WISCONSIN ELECTRIC POWER
COMPANY

(Point Beach Nuclear Plant,
Units 1 and 2)

Amendment to License Nos.
DPR-24 and DPR-27
(Increase Spent Fuel
Storage Capacity)

APPLICANT'S ANSWERS TO INTERROGATORIES
PROPOUNDED BY THE STATE OF WISCONSIN
ON OCTOBER 2, 1978

Figure 1

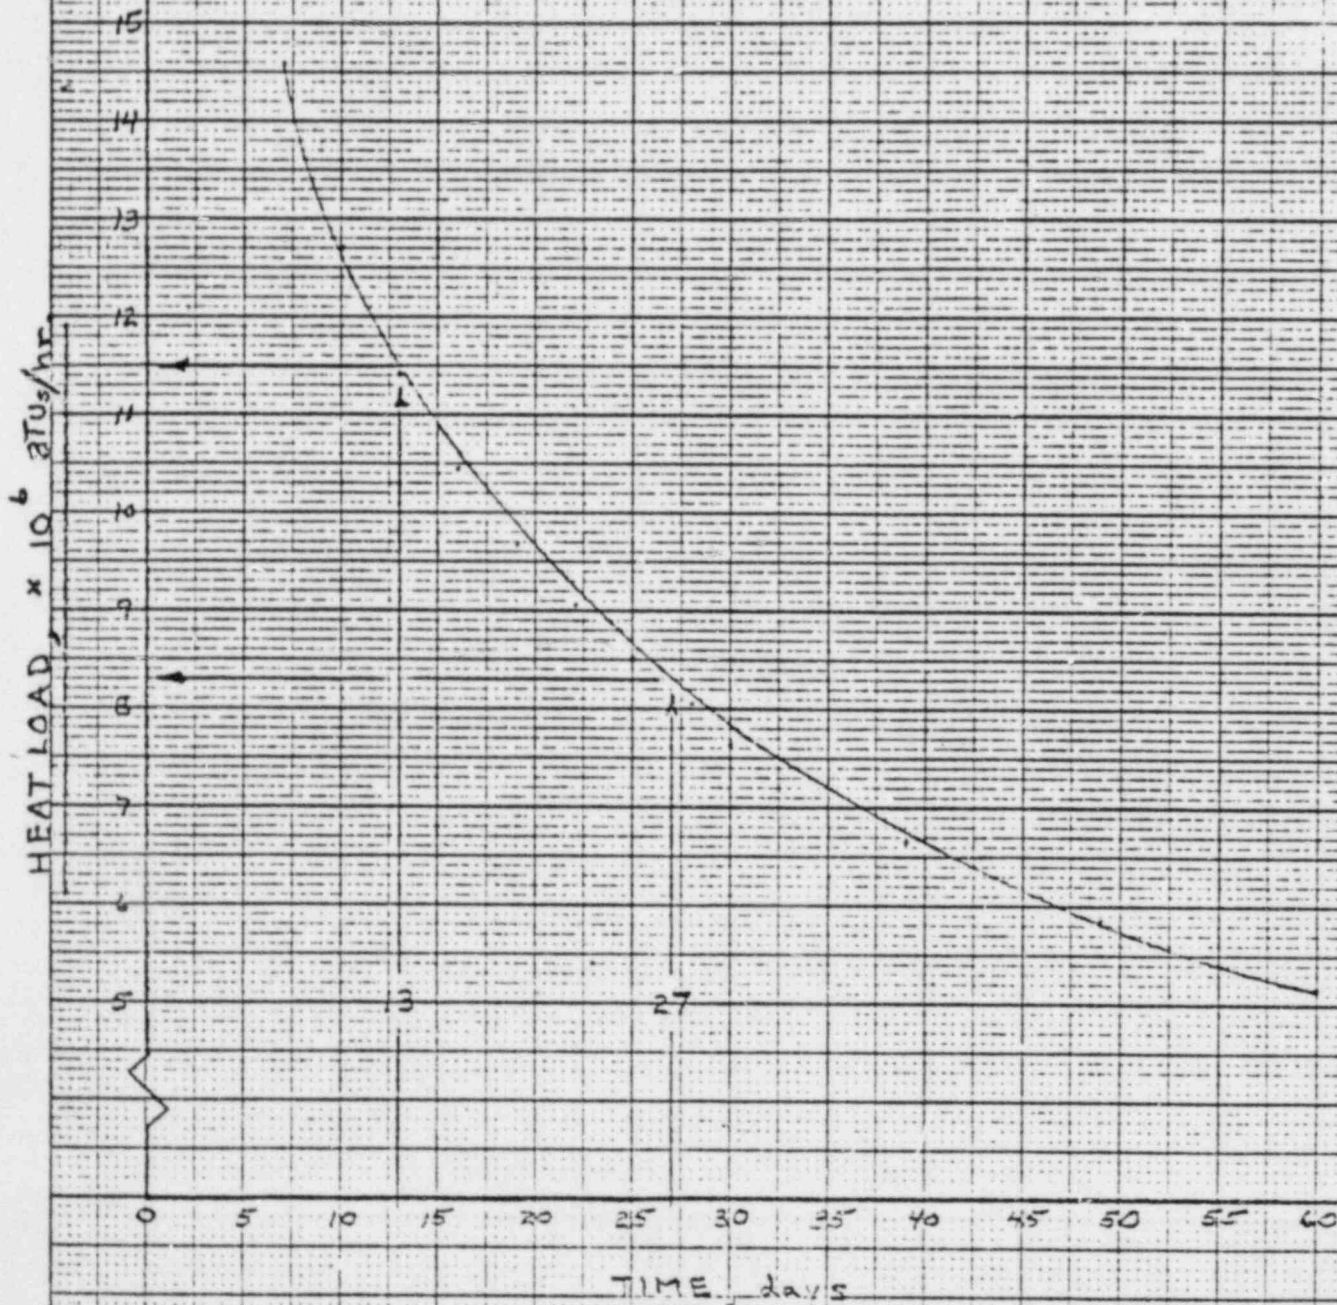
What would be the maximum water temperature reached within the spent fuel pool were cores from both nuclear facilities at Point Beach offloaded into the pool? In calculating this temperature, please assume that the offload of both cores would result in the spent fuel pool being full. Please state the model utilized in calculating this temperature, as well as any assumptions relied upon. How would an increase in the water temperature in the spent fuel pool affect the quantity and quality of radioactive emissions from the pool? Were a temperature increase in the pool to result in boiling and a loss of coolant, how would the quality and quantity of radioactive emissions from the pool be affected? Please state the model utilized and assumptions relied upon in making this determination. What would be the radiation dose received by a person standing next to the spent fuel pool during such a rise in temperature?

Under the postulated conditions, 1260 storage positions would be filled with 242 spaces available for unloading the two cores. The two core unloads in this situation is not realistic but is evaluated for purposes of this interrogatory.

In order to evaluate the pool water temperature, it is first necessary to establish a time sequence of events and calculate the total heat load in the pool. The computer program identified in Section 4.2 of Attachment A to the Application has been utilized to develop the heat loads for this situation. Figure 1 attached is a plot of the decay heat for a full core unload as a function of time after reactor shutdown.

The heat load that would be in the spent fuel pool is established as follows, assuming that 13 days are required to unload a core and that the cores are unloaded sequentially with one day pause between unloadings:

a.	decay heat from the second core unload 13 days after shutdown of reactor (from Figure 1)	11.5x10 ⁶ BTUs/hr
b.	remaining decay heat from the first core unload 27 days after shutdown of reactor (13 days for unloading the first reactor, 1 day pause, 13 days for unloading second reactor; from Figure 1)	8.3x10 ⁶ BTUs/hr
c.	residual decay heat from 1260 in-storage assemblies (use 1280 assembly line from Table 4-1 of Attachment A to this Application - no further decay accounted for)	9.38x10 ⁶ BTUs/hr
		<hr/>
	Total decay heat load in pool	29.18x10 ⁶ BTUs/hr

Normally, only one of the two cooling trains is used to maintain the temperature of the pool water at 120°F or less. Using both trains, the cooling system has a design capability to maintain the pool temperature at 120°F with a heat load of 28.2x10⁶ BTUs/hr. The above calculated number exceeds the design capability of the cooling system by 0.98x10⁶ BTUs/hr, or less than 3.5%. However, there is over 5% more heat transfer surface area in each heat exchanger (per the heat exchanger technical manual data sheet) than is used to calculate the design capability. Thus, the cooling system could accommodate the above postulated heat load and still maintain the pool temperature around 120°F.

FIGURE 2

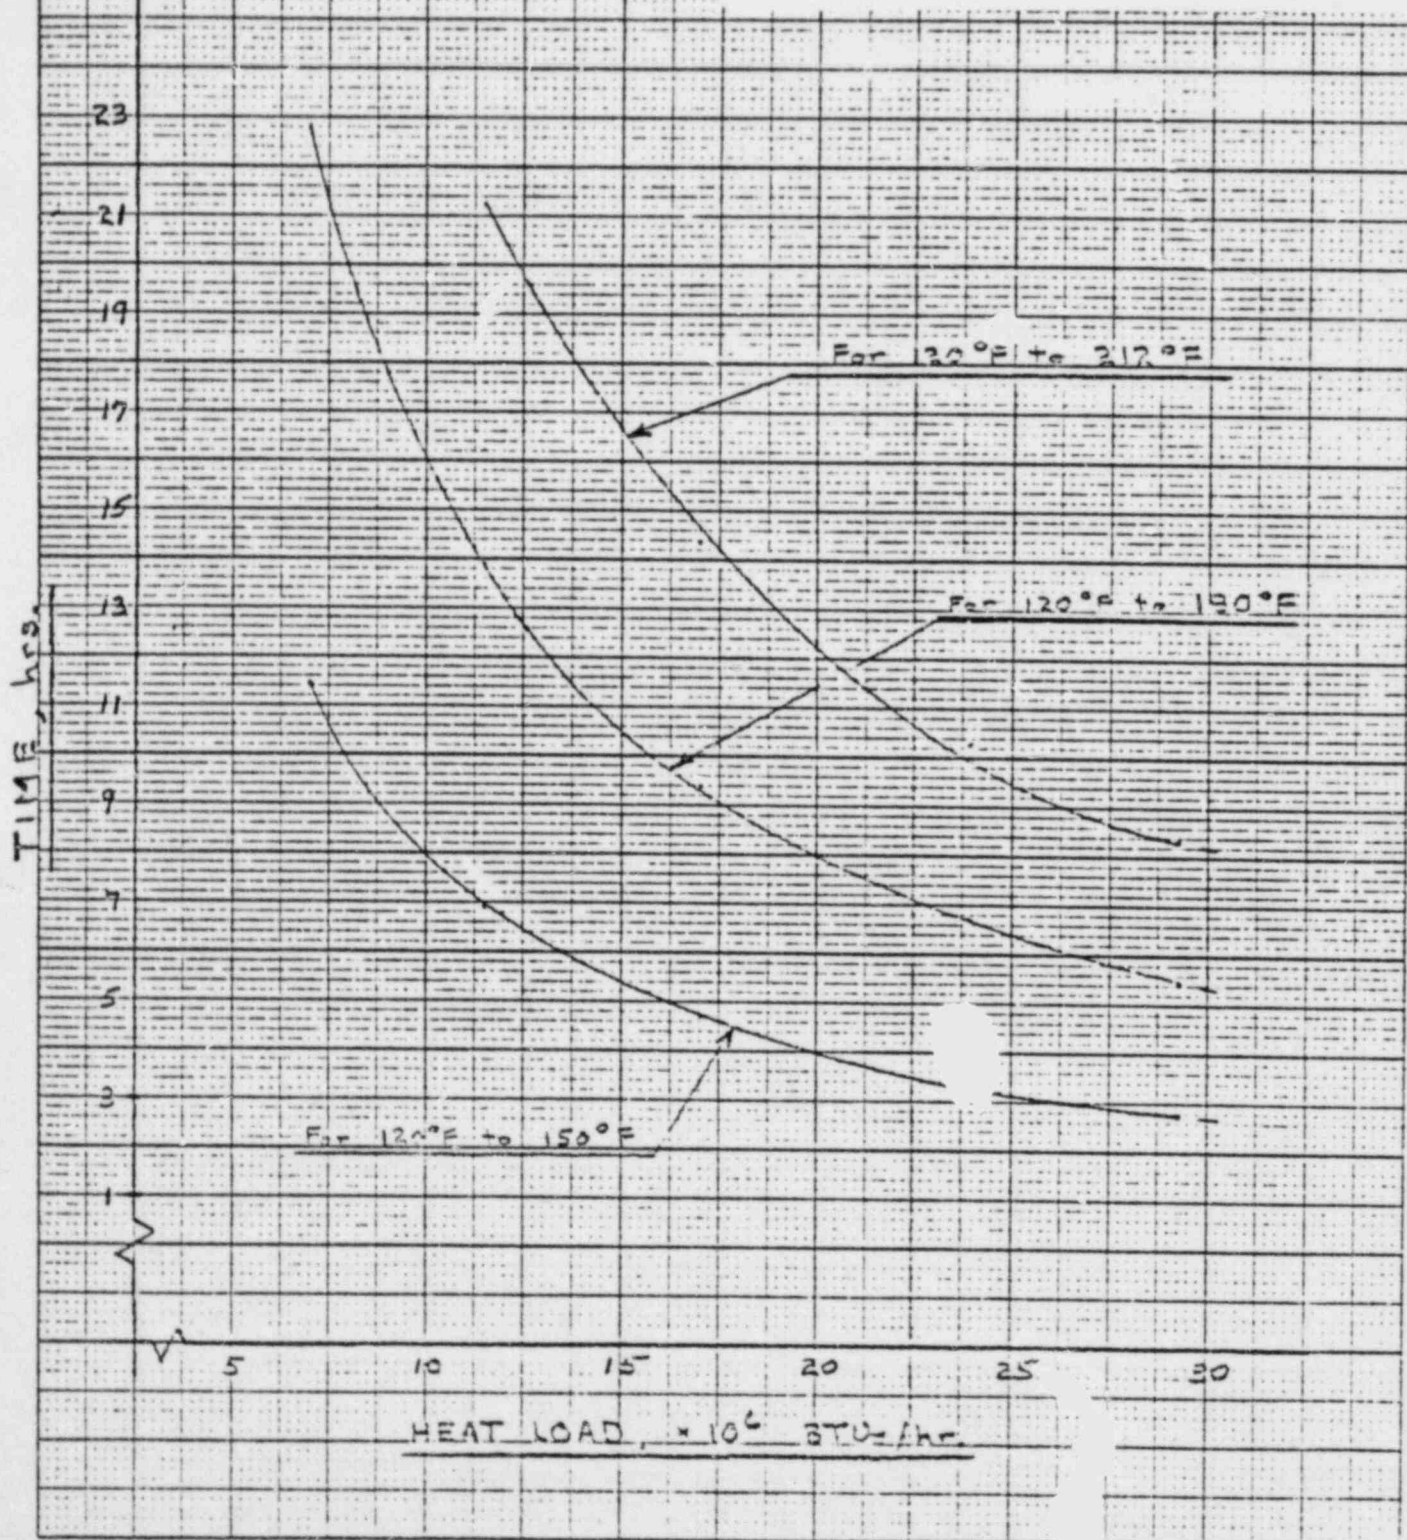
What precautions have you taken to prevent the blockage of the coolant inflow and outflow pipes in the spent fuel pools? What would be the effect on the temperature of the pool of a blockage of either the inflow or outflow pipe? Would such a blockage cause an increase in radioactive emissions from the pool, due either to the inability to filter the pool's water during blockage or due to increased temperatures during blockage? If not, why not? If your answer is yes, please state the expected increase. Also state the model utilized and the assumptions relied upon in making your determination.

piping prior to reaching each pump. If somehow an eight-inch suction pipe was blocked, the cooling could simply be transferred to the other cooling train. If somehow the ten-inch suction pipe was blocked, the cooling system would be shut down until the pipe was cleared. There is a set of bolted flanges in the ten-inch piping (originally installed for pressure testing purposes) and bolted flanges are used to connect the piping to the pumps. These flanges could be disconnected and the lines cleaned out if necessary.

If the cooling system were turned off, the pool water temperature would increase during the time period for cleaning out the blocked line. Figure 2 shows the time required to heat up the spent fuel pool as a function of heat load.

There would be no increase in radioactive emissions from the pool unless the water temperature were to reach the boiling point. Refer to the answer to Interrogatory 5 for the consequences of boiling.

3. Irradiation Testing of 50% B₄C Boraflex

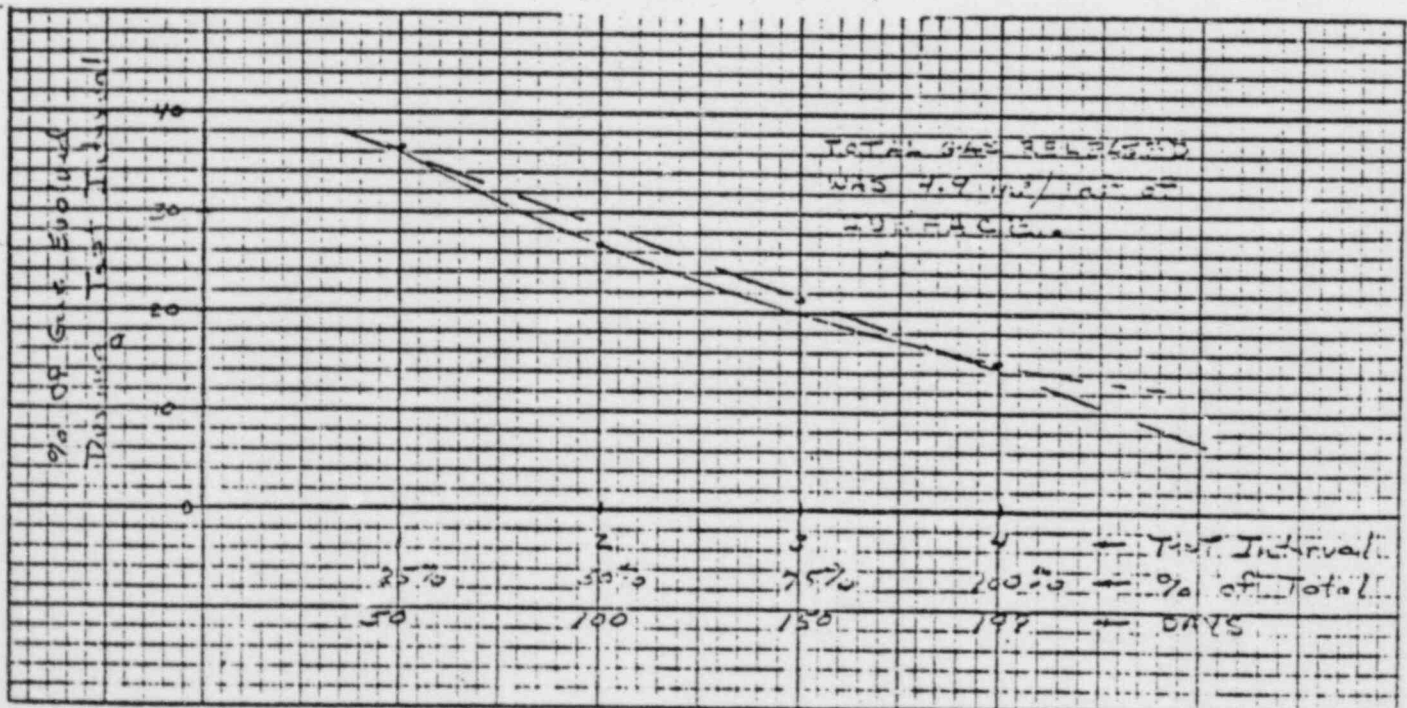
In your response to Question A-12, you cite long-term radiation studies documented in BISCO Report 1047-1. Under what conditions, were these studies conducted; by "conditions", I am referring to the gamma flux to which the boraflex I plates were subjected, the time period in which they were subjected to gamma flux, and the medium (water, air, etc.) in which the experiments took place.

The samples were irradiated and tested at the University of Michigan. The long term irradiation data is presented on page 5.

The irradiation of 8.53×10^{17} N/cm² produced a weight loss of about 6% with a decrease in all of the dimensions.
